# PLANNING AND ZONING CASE CHECKLIST

P&Z CASE # M152020-017 P&Z DATE 12/8/20 CC DATE \_\_\_\_\_ APPROVED/DENIED \_\_\_\_\_  
ARCHITECTURAL REVIEW BOARD DATE \_\_\_\_\_ HPAB DATE \_\_\_\_\_ PARK BOARD DATE \_\_\_\_\_

MIS2020-017- VARIANCE REQUEST FOR HARBOR POWER POLE  
MISCELLANEOUS - LOCATION MAP =

**SUBJECT:** MIS2020-017; *Variance Request for Harbor Heights Condominiums*

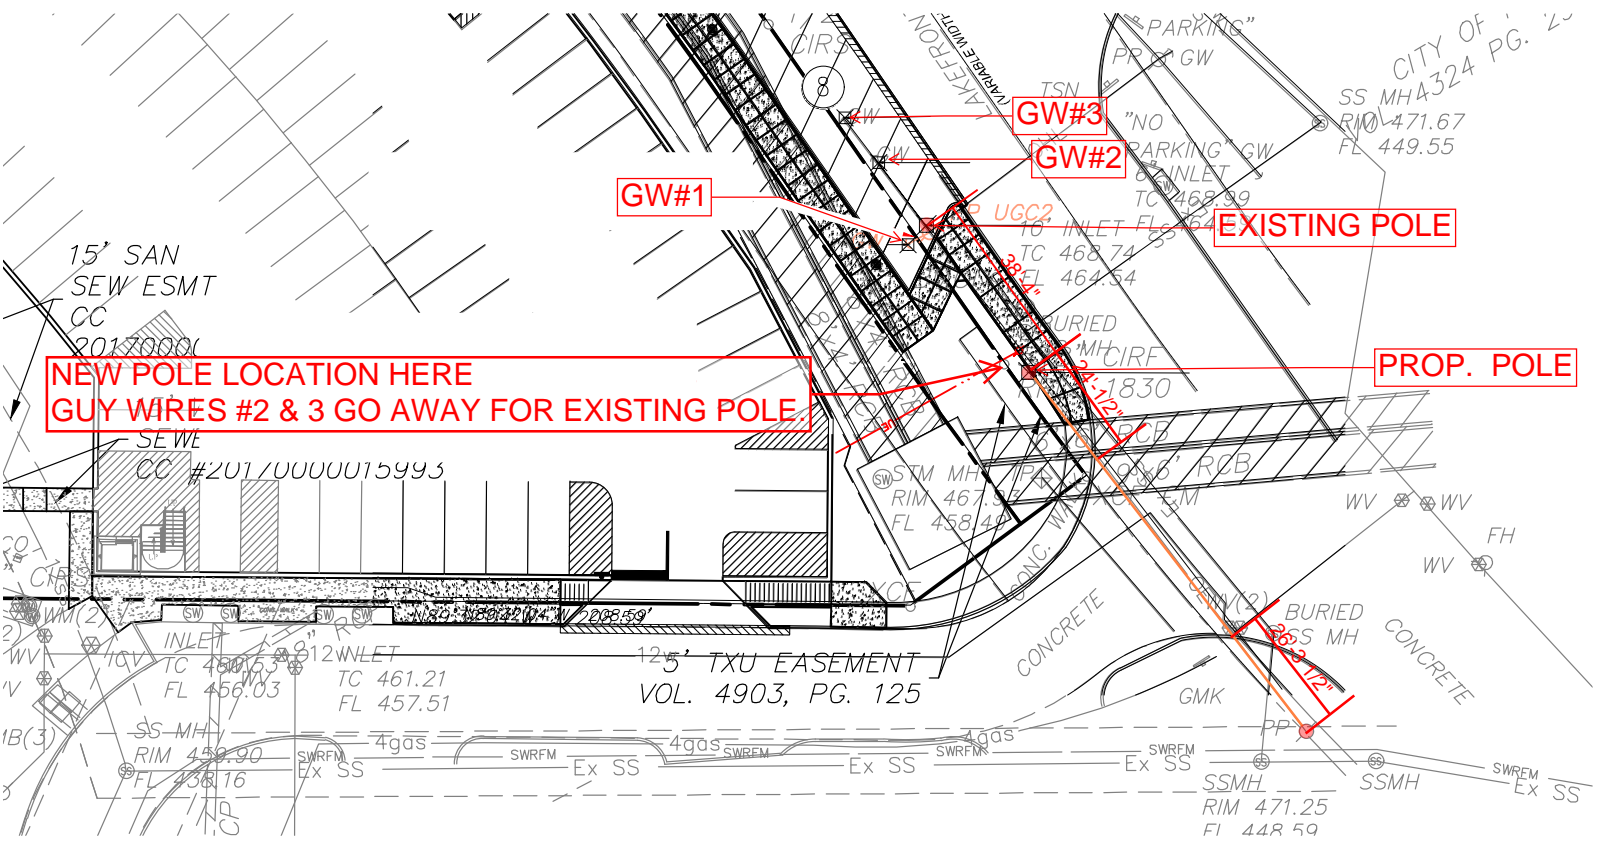
Attached is the Zoning Application for the variance needed so that we can set a pole to supply power the retail parking garage we currently have under construction at The Harbor.

As we discussed this variance is necessary due to the fact that site conditions do not allow for a transformer to be set next to the structure where the power currently enters the property. There exists two side by side 48" RCBs that cut across the property and there is not enough room between them and the Lakefront Trail right of way to allow for a ground mounted transformer. The new pole will be added in line next to an existing pole. Power will drop down from the new pole and run under ground to the new parking structure.

NEW POLE LOCATION HERE  
GUY WIRES #2 & 3 GO AWAY FOR EXISTING POLE

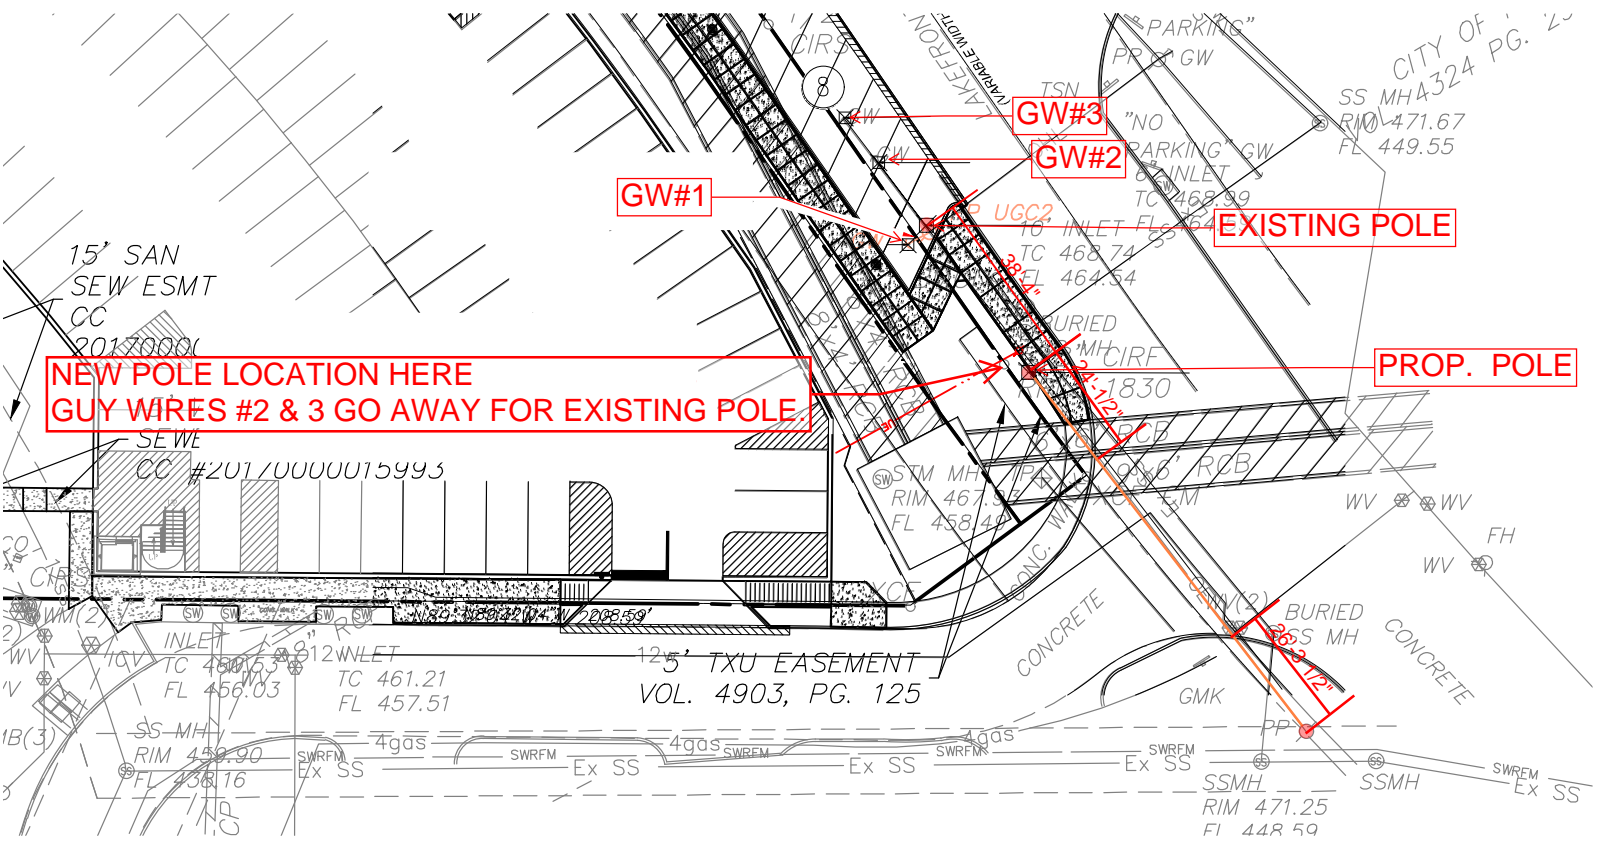
Good afternoon, Thank You for your time meeting with Cindy and I. Per our discussion on Monday, I have researched every option in getting this project completed within the City's Ordinance. In this case I am unable to remove the pole located at the parking space due to the location of the down guys that are holding the pole line going across the street. If this pole is to be relocated to the other side of the sidewalk the down guys on both sides would change angles and would conflict with the sidewalk and the Storm water inlet, if I changed to a concrete pole and removed the down guys there is not sufficient space for a deadend concrete pole being 3ft in diameter. If the existing pole could stay in place losing one parking space and installing one pole in lead to the south of the inlet would enable us to place to down guys on the new pole and removing the guys from the existing pole only losing one parking space and would allow Oncor able to back up the existing pole going south. This pole line going south along Lakefront Trail is a feeder which is heavy wire requiring the line to be guyed at both ends. I have attached a drawing to indicate this.

NEW POLE LOCATION HERE  
GUY WIRES #2 & 3 GO AWAY FOR EXISTING POLE
